Safety Evaluation Report

related to the operation of
**Seabrook Station,
Units 1 and 2**

Docket Nos. 50-443 and 50-444

July 1985

Figure 2.7 (revised) Wave protection stone revetment and seawall
Source: FSAR Figure 2.4-20

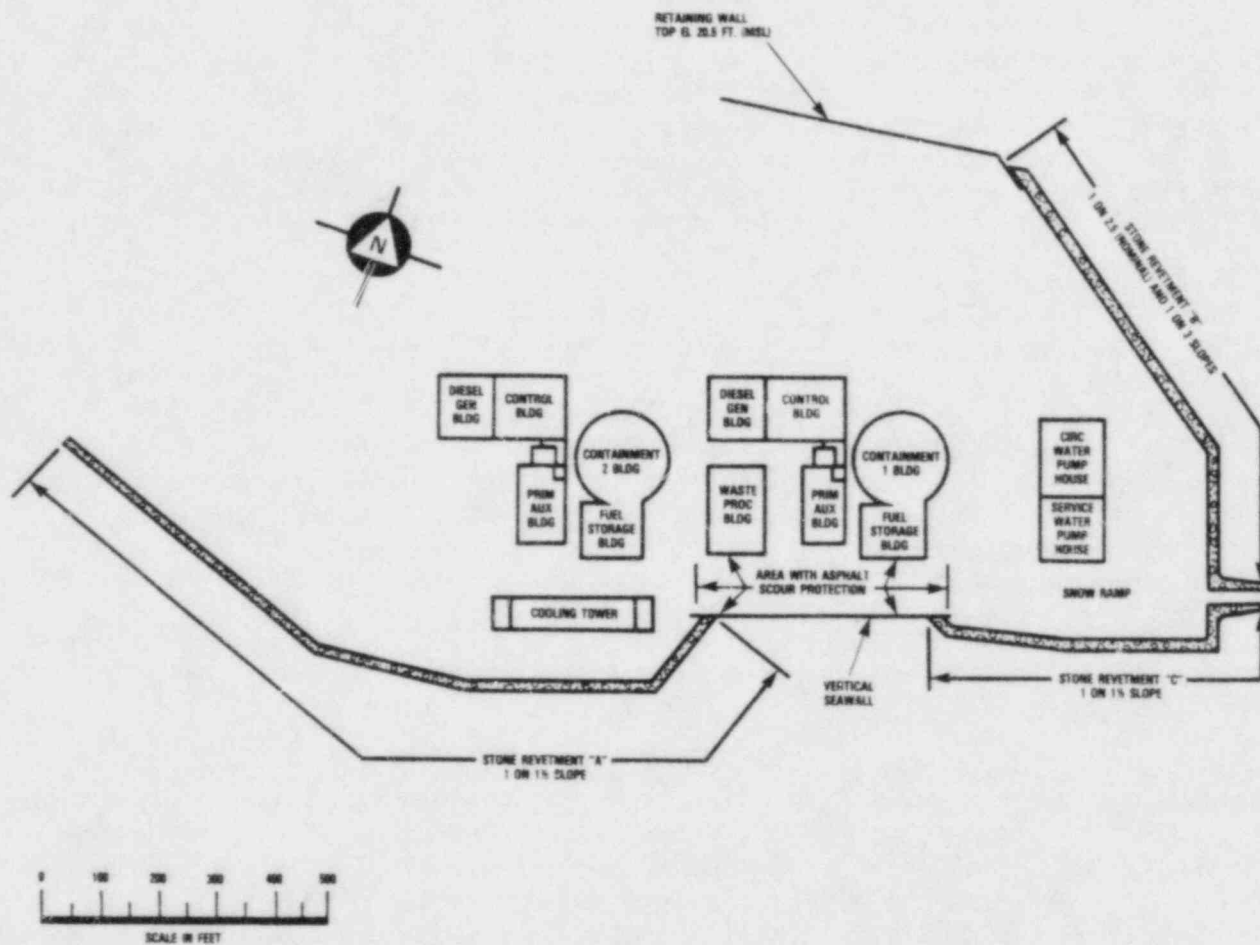
Subsequent to the SER, the applicant has revised the shore protection features on the basis of changes in site conditions that occurred during the construction stage. During construction the land area on the east side of revetment B was graded to about elevation (el) 13 ft mean sea level (msl). The original design for revetment B was based on the revetment with a 1 on 2 slope extending to the original marsh elevation. On the basis of these changed conditions, the applicant has determined that the higher ground on the harbor side of revetment B provides significant protection. The changed conditions result in a reduction in the design waves that can impact revetment B during the design-basis hydrologic event (probably maximum hurricane). As a result, the applicant has redesigned stone revetment B from a 1 on 2 slope to a structure with both a 1 on 3 slope and a nominal 1 on 2.5 slope and reduced the weight of armor stone required for the revetment consistent with the reduced design wave height (see revised Figure 2.7).

In addition, the applicant has addressed the confirmatory issue involving the requirement for scour protection to the plant grade area behind the vertical concrete seawall adjacent to electrical manholes #13/14 and #15/16. This area would be subjected to significant wave overtopping and wave scour of plant grade if not protected during the design-basis flooding event. The applicant has stated that asphalt paving, 6 in. thick, will be provided for scour protection (see revised Figure 2.7).

On the basis of its analysis of the changed site conditions, the redesign of revetment B, and the asphalt scour protection, the staff concludes that these shore protection features would survive the design-basis flood. On the basis of its analysis using Sections 2.4.2, 2.4.5, and 2.4.10 of the Standard Review Plan (SRP, NUREG-0800), the staff concludes that the applicant has shown that the plant design-basis flood protection meets the guidelines of RG 1.102 and thus the requirements of GDC 2.

Figure 17.1 Public Service Company of New Hampshire operations quality assurance organization

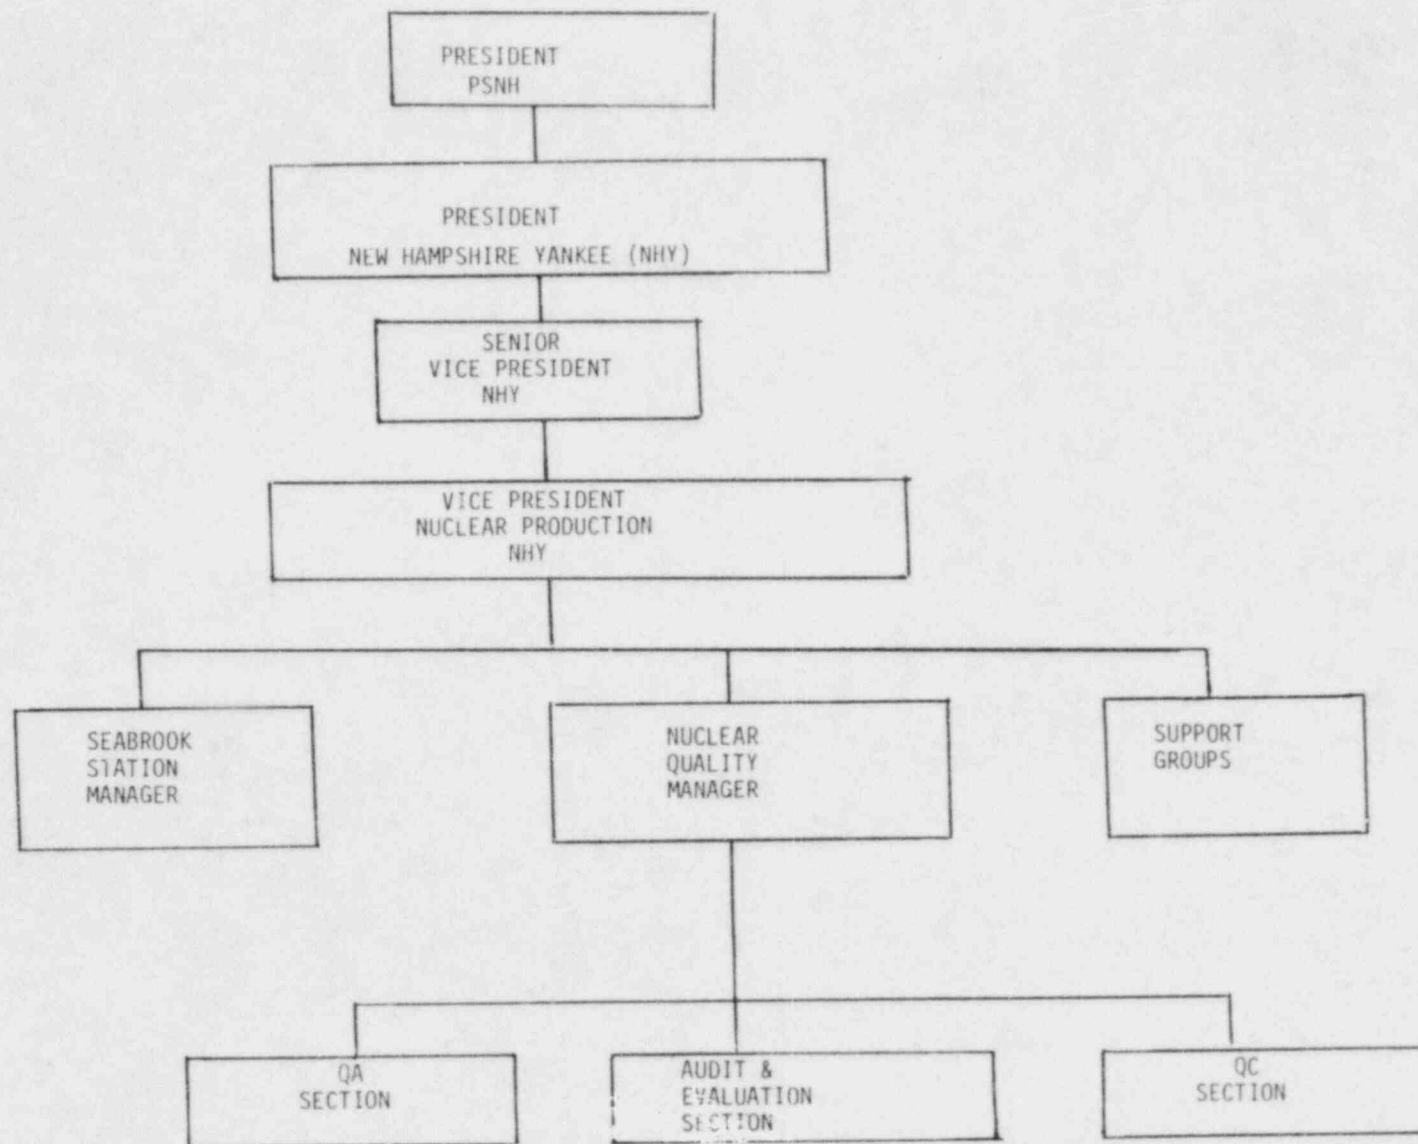
As a result of the applicant's submittal of Amendment 53, which affects the staff's previous SER organizational description for the operation of Seabrook Station, it is necessary that Sections 17.2, "Organization," and 17.4, "Conclusions," and the quality assurance (QA) organizational chart (Figure 17.1) be replaced by the following.

The structure of the organization responsible for the operation of Seabrook Station and for the establishment and execution of the operations phase QA program is shown in Figure 17.1. The Public Service Company of New Hampshire (PSNH) President has delegated to the New Hampshire Yankee (NHY) President (a division within Public Service Company of New Hampshire) the direct responsibility for operation, maintenance, modification, and refueling of Seabrook Station, Units 1 and 2. The NHY Vice President of Nuclear Production reports through the NHY Senior Vice President to the NHY President and is responsible for the operation and operational support of Seabrook Station, Units 1 and 2, including QA functions. The Seabrook Station Manager, the Nuclear Quality Manager, and other support groups report to the NHY Vice President of Nuclear Production. The Nuclear Quality Manager is in charge of the Quality Assurance Department, which consists of a Quality Assurance Section, an Audit and Evaluation Section, and a Quality Control Section.
